ELM CREEK PRO JZ22-28

JZ22-28 ELM CREEK PRO PLAN WITH REZONING 18.737

Public hearing at the request of Toll Brothers, Inc. for Planning Commission’s recommendation to City Council for a Zoning Map amendment from Office Service Technology (OST) and Low-Rise Multiple Family (RM-1) to Low-Rise Multiple Family (RM-1) with a Planned Rezoning Overlay. The subject site is approximately 37-acres and is located south of Twelve Mile Road, west of Meadowbrook Road (Section 14). The applicant is proposing to develop a two-phased 134-unit multiple-family townhome development.

PRO Concept Plan: Formal Submittal

SHEET 7

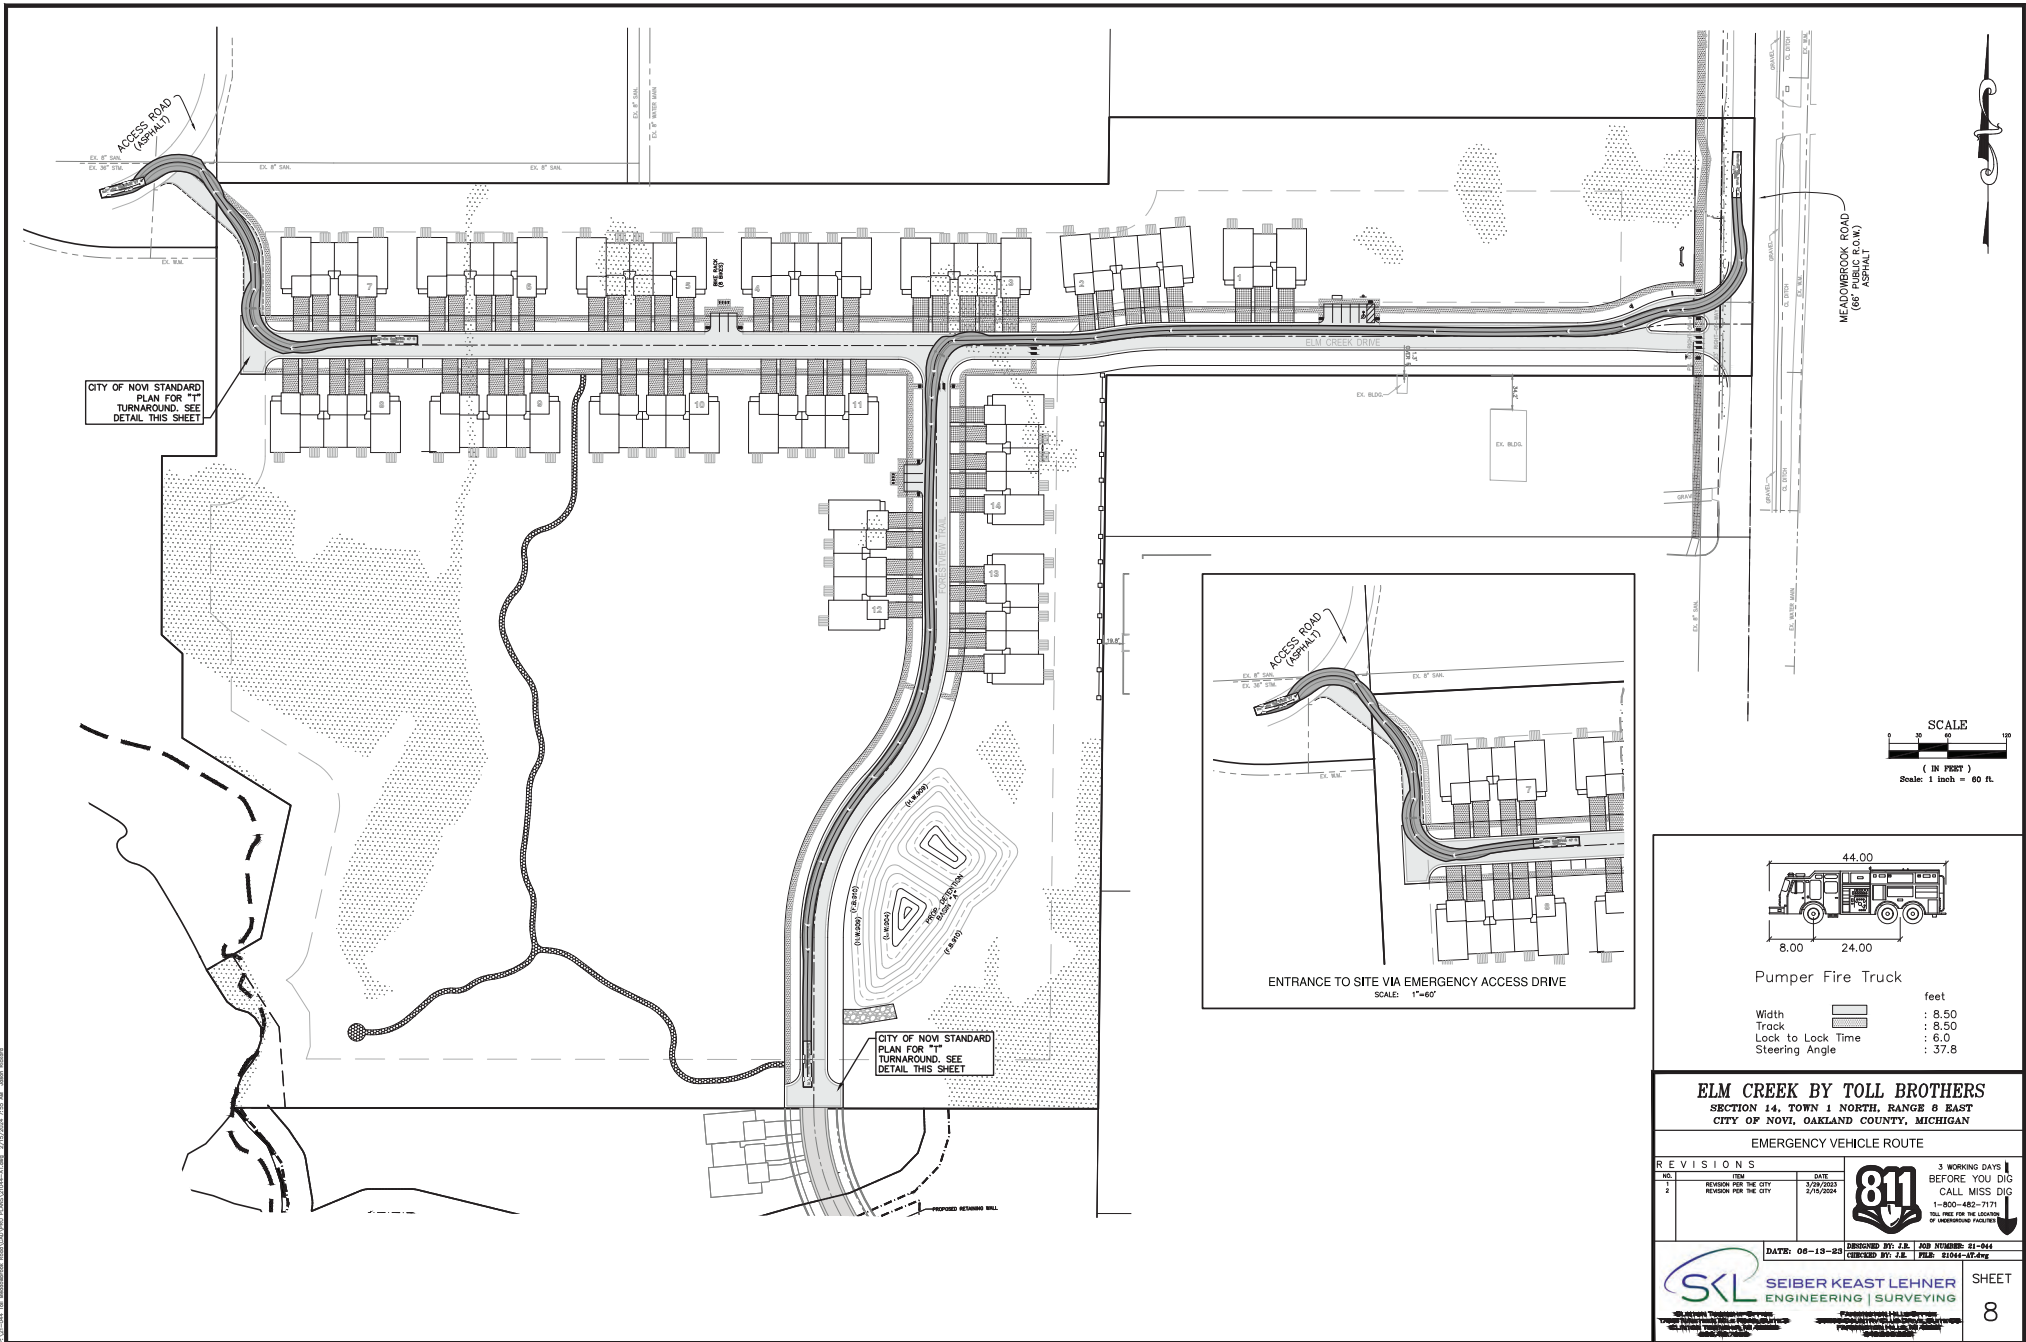
6. Screening between adjacent properties including fences and landscaping as shown in the PRO Plan.
 7. A cul-de-sac shall be provided at the terminus of the road in Phase 2 rather than a temporary T-turn, since it is unlikely that the road will connect to future development to the south. If Phase 2 of the project does not move forward in a timely manner, the temporary T-turnaround shall be changed to a cul-de-sac.

L-4

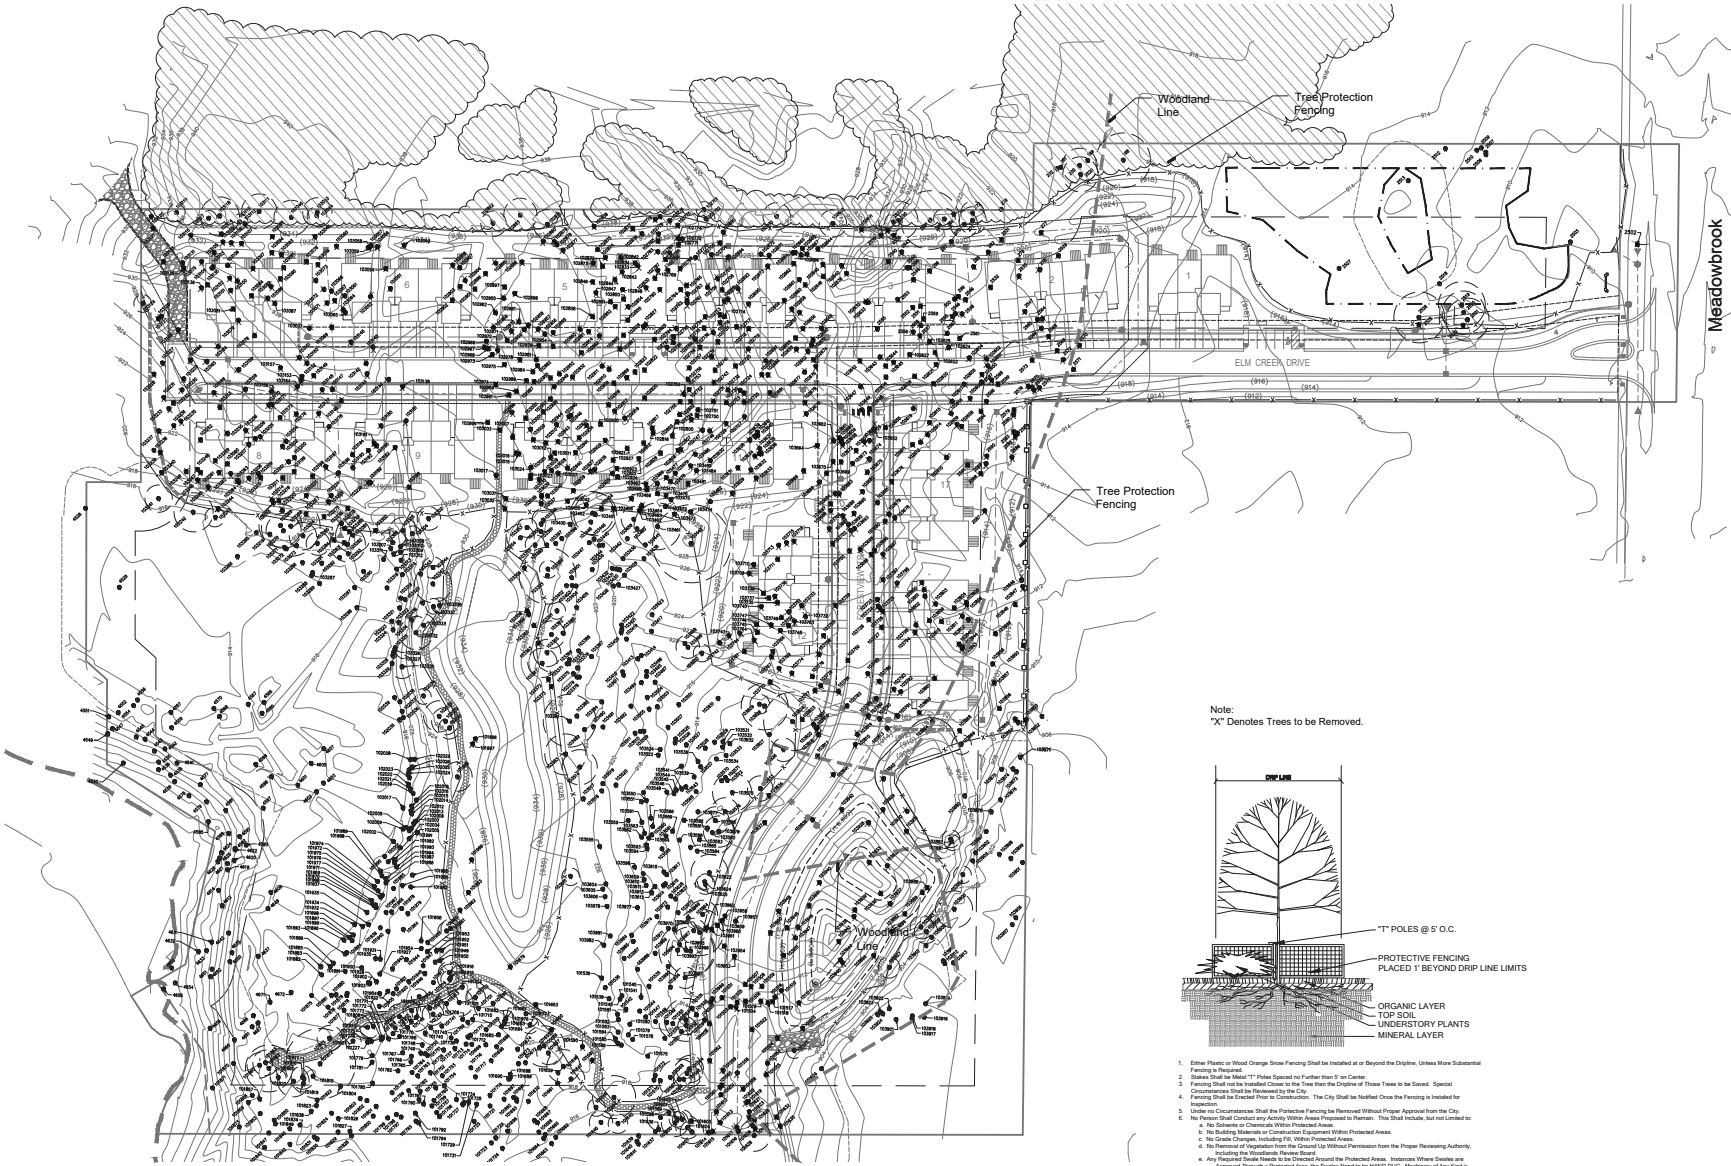
- a. DRG requested that the cost to stake, install, and remove the tree protection fencing be added to Sheet L-3 in order to calculate woodland fence inspection fees. Prior to final site plan approval this should be added to either Sheet L-1 or L-3.
